MITIGATION PLAN

LAUREL VALLEY MITIGATION SITE

Burke County, NC
NCDEQ Contract No. 7875-02
DMS ID No. 100140

SUBJECT: NCDMS Laurel Valley Mitigation Project - NCIRT Comments during 30-day Mitigation Plan Review, Burke County, NC

Figure 9 Monitoring Map
 Laurel Valley Mitigation Site
 Catawba River Basin 03050101

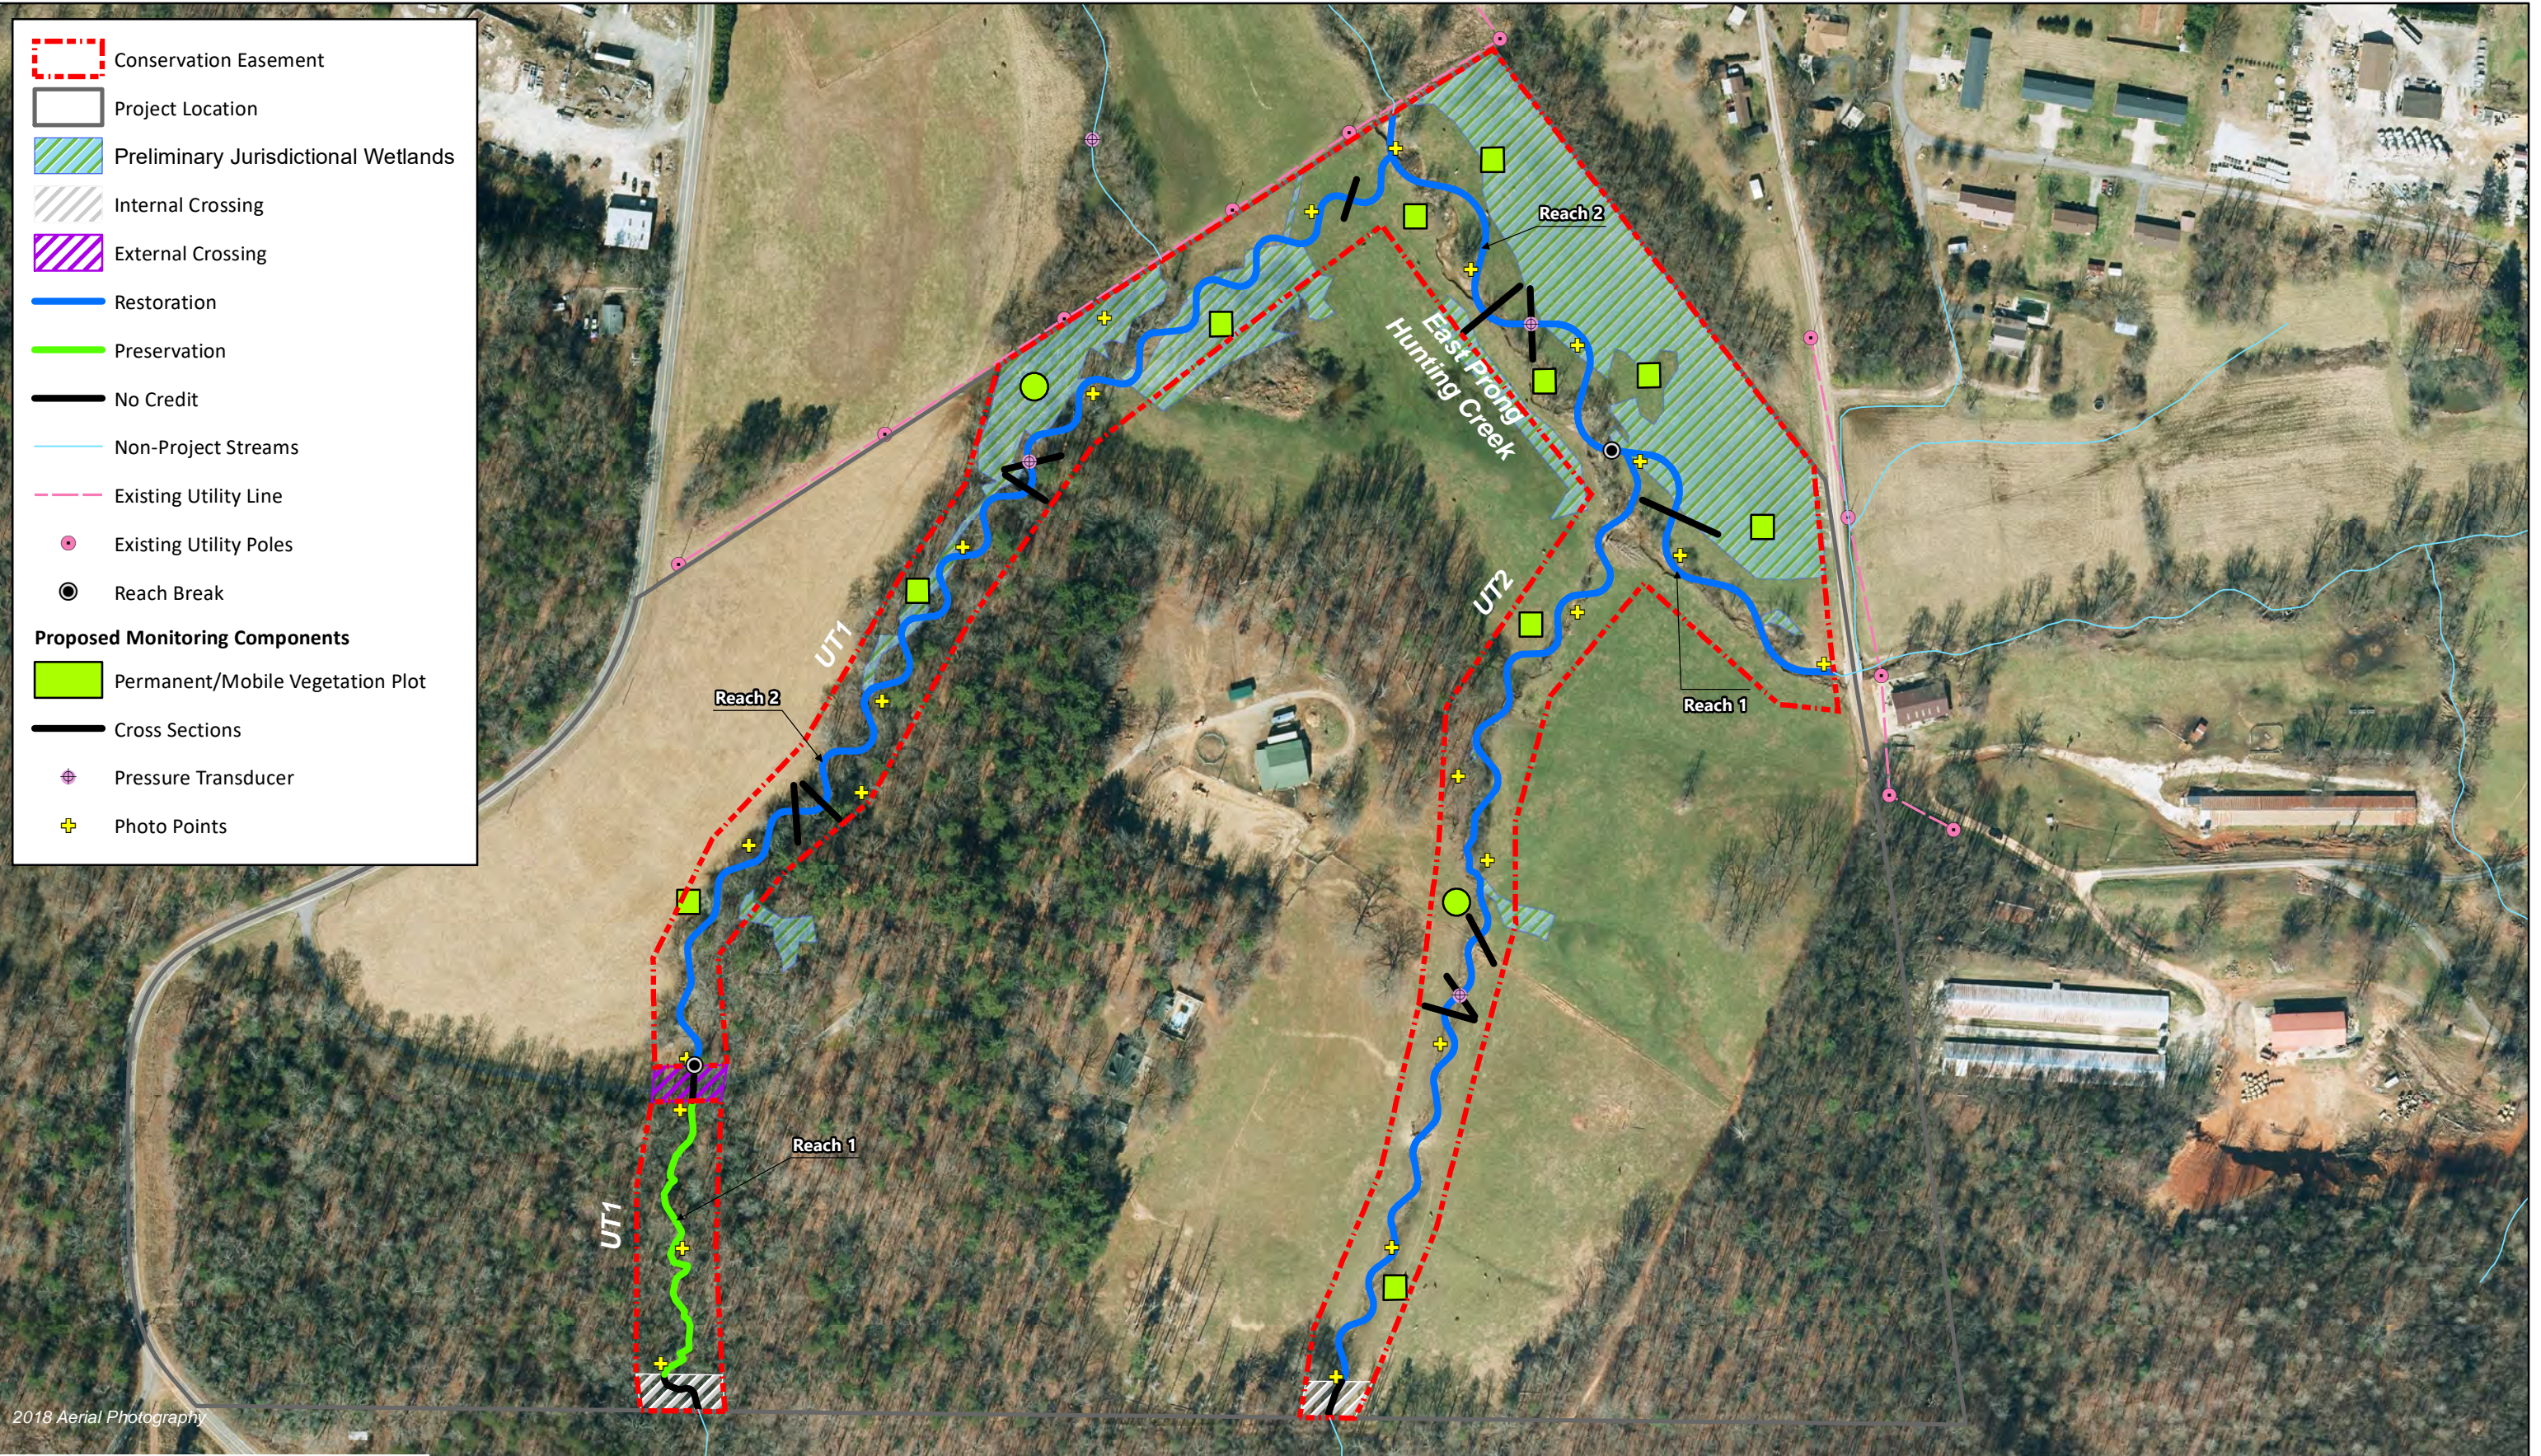
8. Figure 2 – Please callout the approximate locations of existing ditches/drainage outlets referenced in the text.
9. Figure 9 – Please show existing wetlands.

23) Figure 9: Please show existing wetlands.

a) Existing wetlands are now shown on Figure 9.

a) An additional cross-section has been added to the downstream area of UT1 Reach 2. Table 19 (Monitoring Components) and Figure 9 (Monitoring Map) were updated to include these additional monitoring components.

Figure 10 Planting Zones
 Laurel Valley Mitigation Site
 Catawba River Basin 03050101

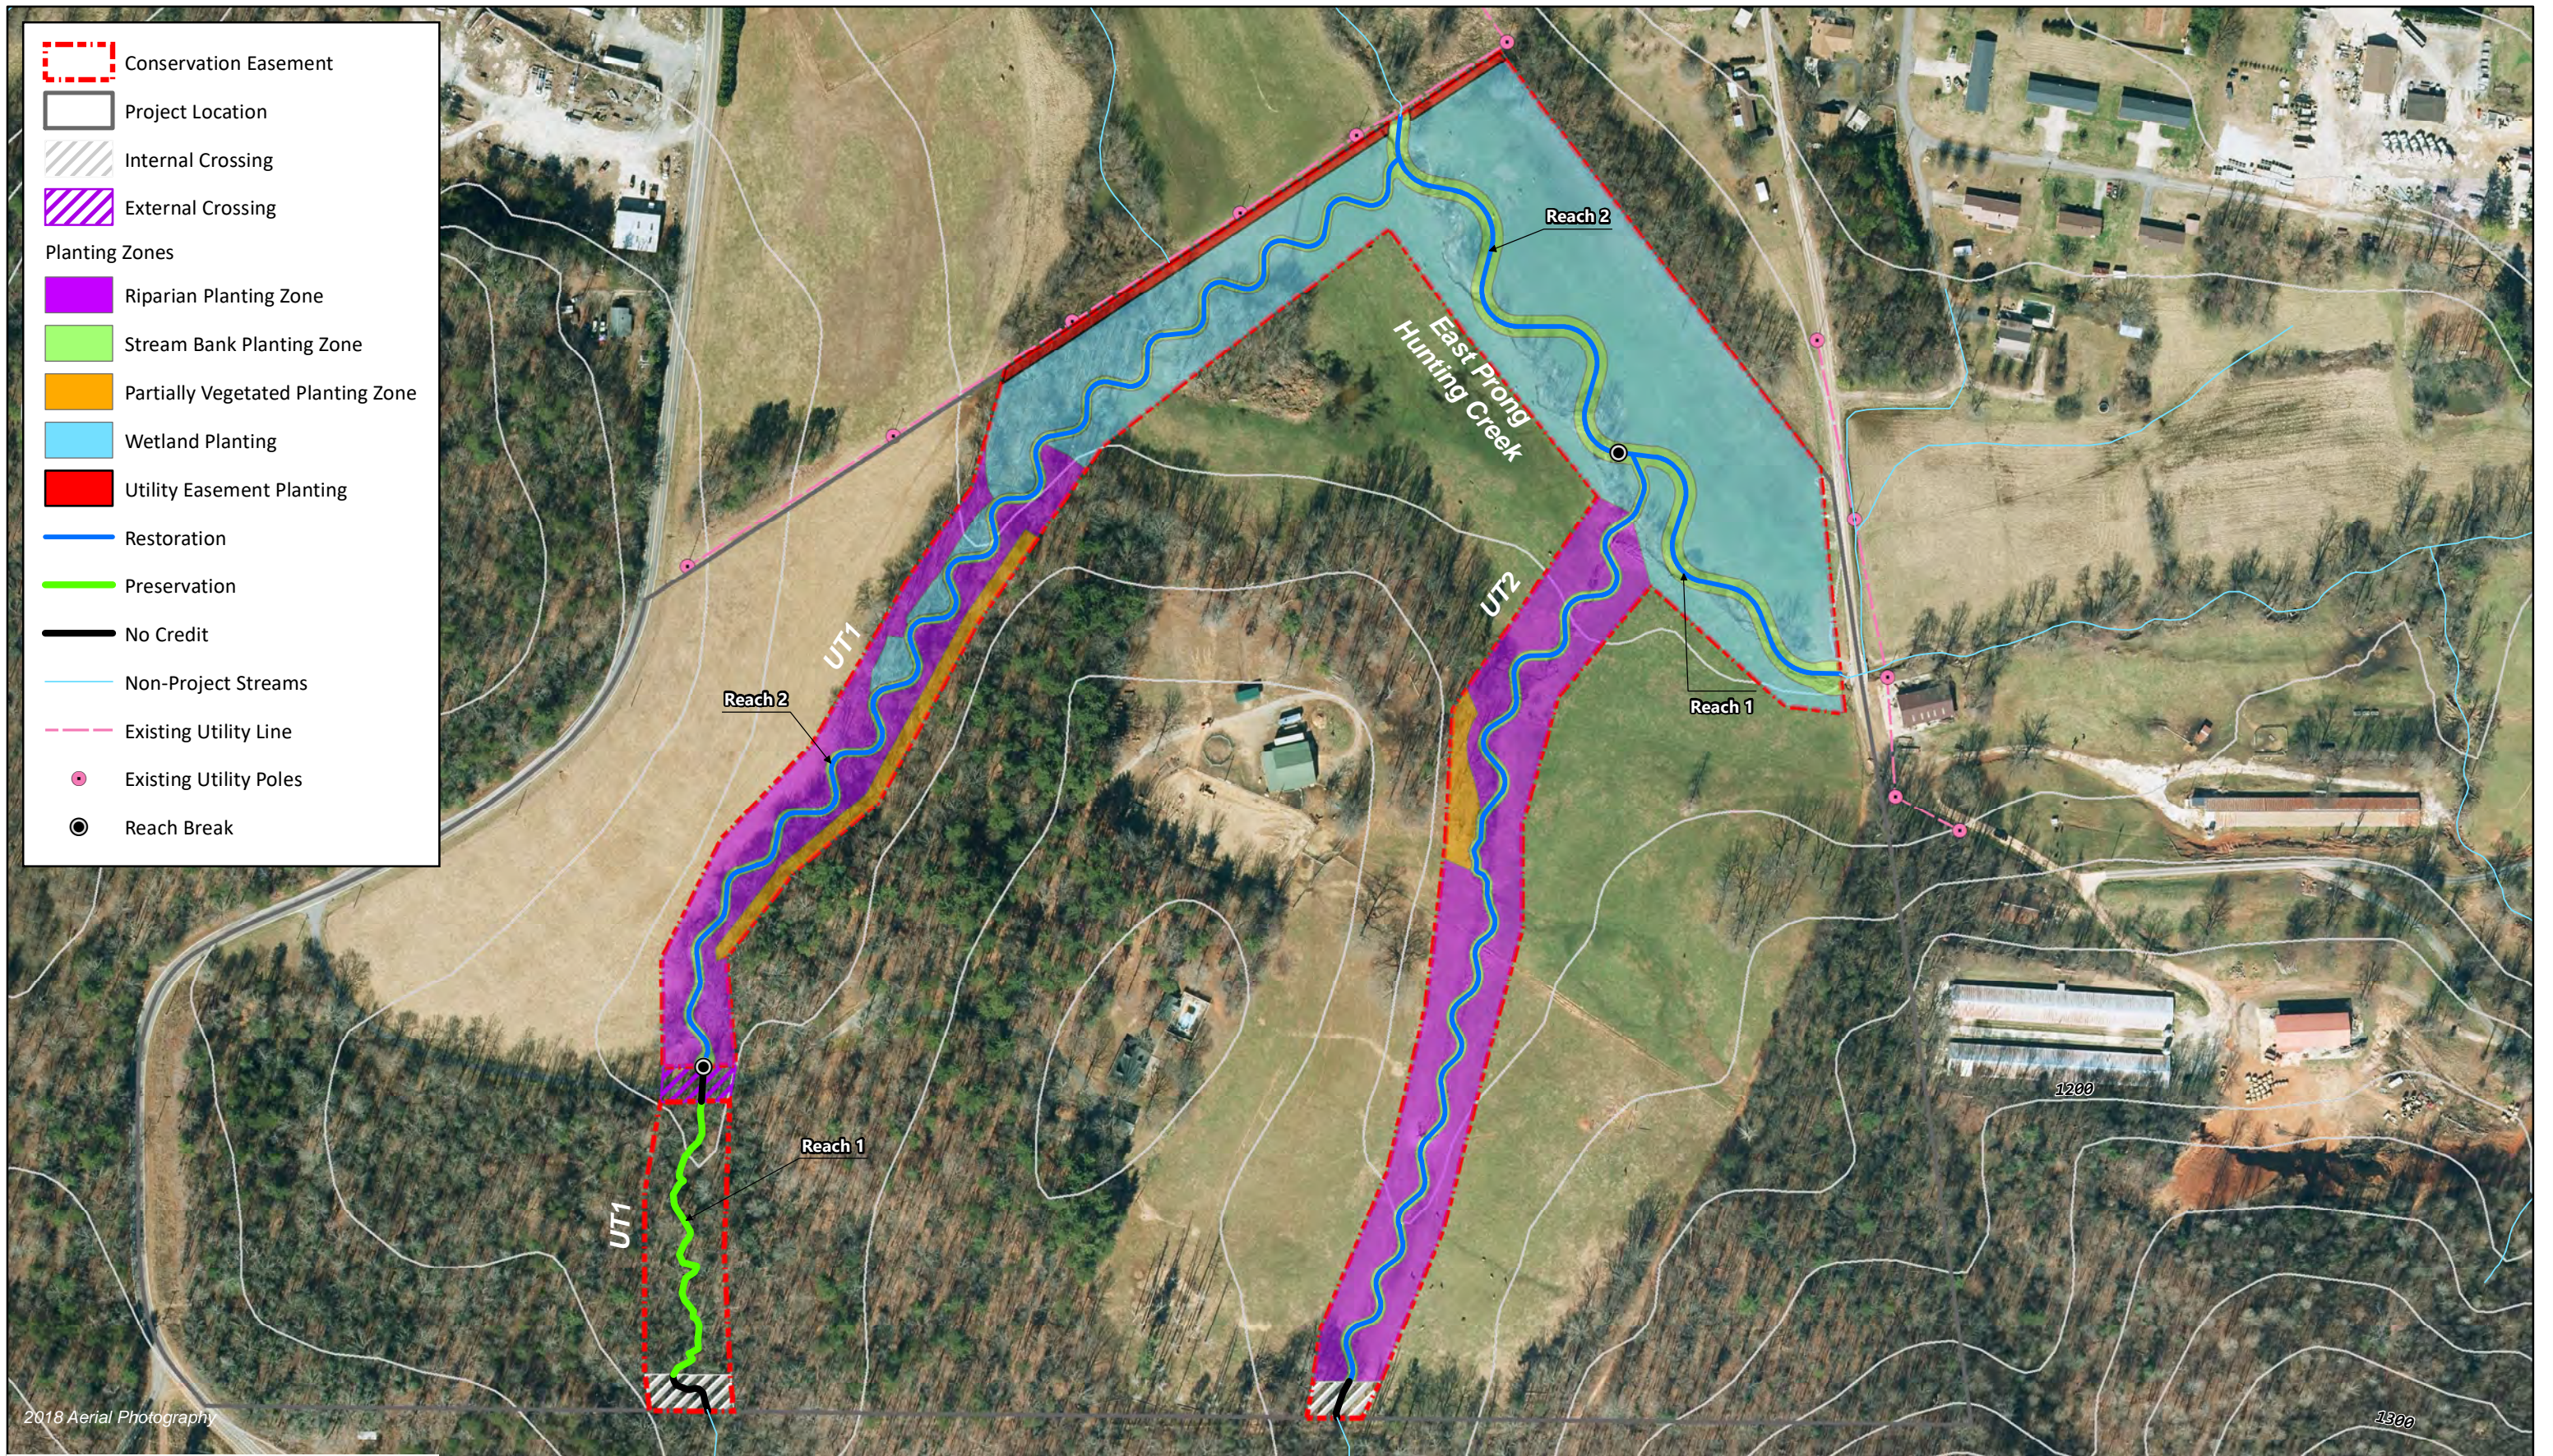
5. Page 22, Section 6.7 – Please briefly describe the proposed utility easement planting shown on Figure 10.
6. Page 27, Table 18 – DWR is ok with the proposed Wetland Planting Zone vigor standard.

a) Please briefly describe the proposed utility easement planting shown on Figure 10.
